Access Compliance Report

Public Rights-of-Way

(Island Curb Cuts)

Intersection ID: 5600	Main Street: N_TRYON_ST	Cross Street: J_M_KEYNES_DR	Location: S
ADA ID: BBD4F4CA01D3	Curb Cut Type: MedianRefuge2	Initial Pass/Fail: Fail	Overall Compliance: No
Severity Score: 0			
Codes/Mitigation Info/Possible Solution		Field Measurements/Component Compliance

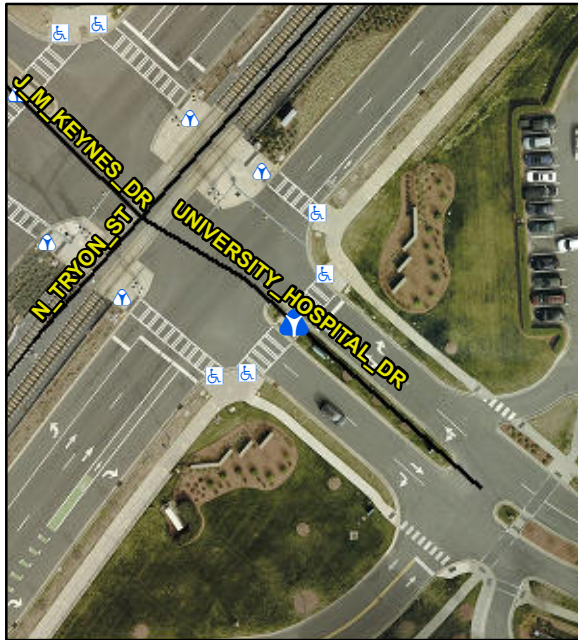
Possible Solutions:

RECENTLY REPAVED-NO CROSSWALKS

Remove & Replace Entire Refuge.
